# City of Seal Beach

**SUBJECT: CITY OF SEAL BEACH COMMENTS RE: "DRAFT  
EIS/EIR – MIDDLE HARBOR REDEVELOPMENT  
PROJECT (SCH NO. 2004091010)"**

Figure 3.5-1. Study Area

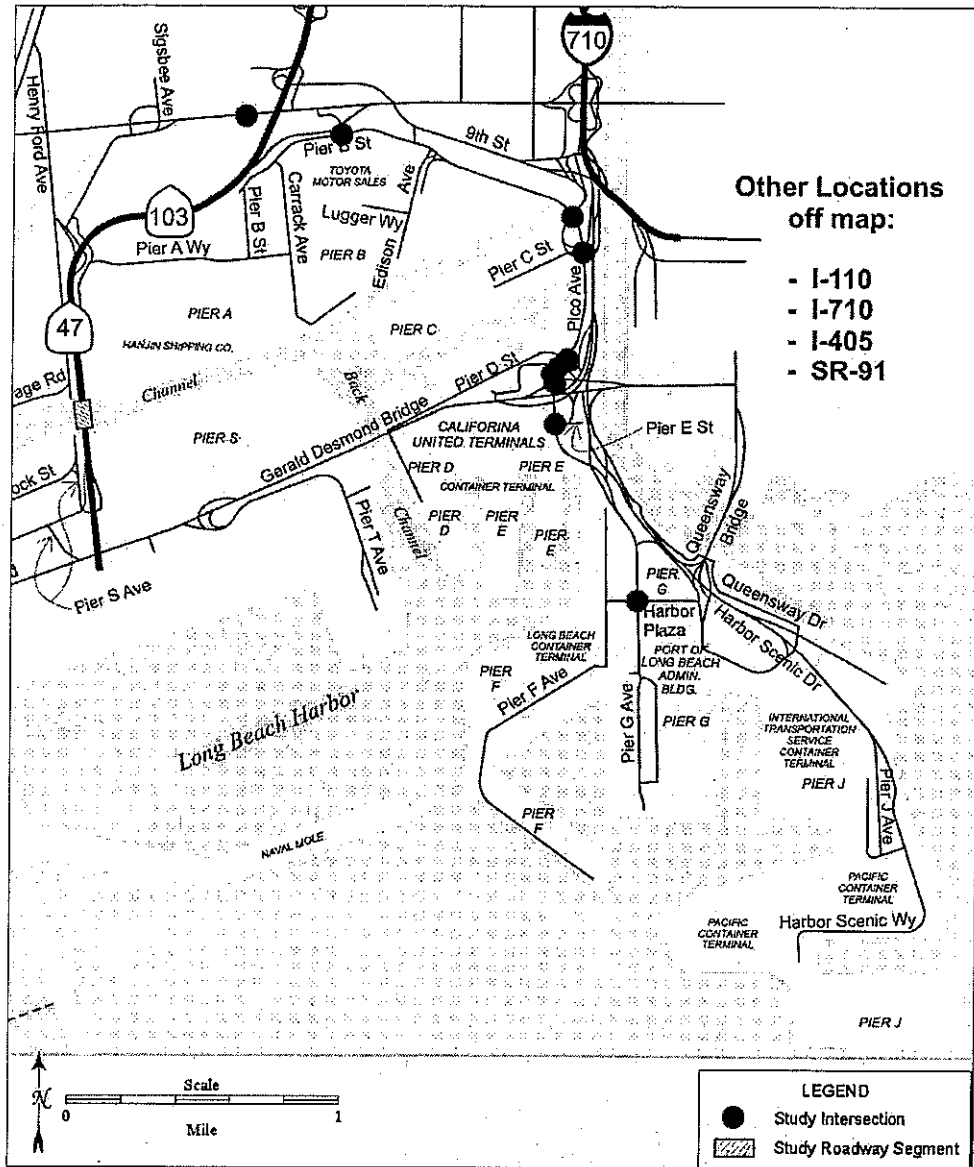
Potential traffic impacts on regional arterial highways were analyzed in conformance with guidelines from the Los Angeles County Congestion Management Program (CMP), adopted by the Metropolitan Transportation Authority (Metro). According to the CMP, a traffic impact analysis is required at a CMP arterial monitoring intersection where the proposed project would add 50 or more trips during either the A.M. or P.M. weekday peak hour. The closest CMP arterial monitoring station to the proposed Project is Alameda Street / Pacific Coast Highway (PCH). Since the Project-related trips do not exceed the CMP minimum threshold at that location, no CMP analysis of the Alameda/PCH station for future conditions was required.

Traffic impacts on freeways were also assessed in conformance with the CMP. Traffic impact analysis for freeway segments is required at CMP freeway monitoring locations where the proposed project would add 150 or more trips during either the A.M. or P.M. weekday peak hours. The traffic study analyzed impacts at seven freeway locations, including locations on I-710, I-405, I-110, and SR-91. The analysis concludes that the project will have significant impacts on some segments of all these freeways. Since the Port does not own, control, or maintain any of the impacted highway segments (they fall under the jurisdiction of Caltrans), it does not have the authority to unilaterally implement any mitigation measures on those segments. The EIS/EIR includes a mitigation measure that requires the Port to pay its fair share of improvement costs if Caltrans either adopts a fair share program to collect funds for mitigation, or obtains the balance of funding needed to improve the impacted highway study segments.
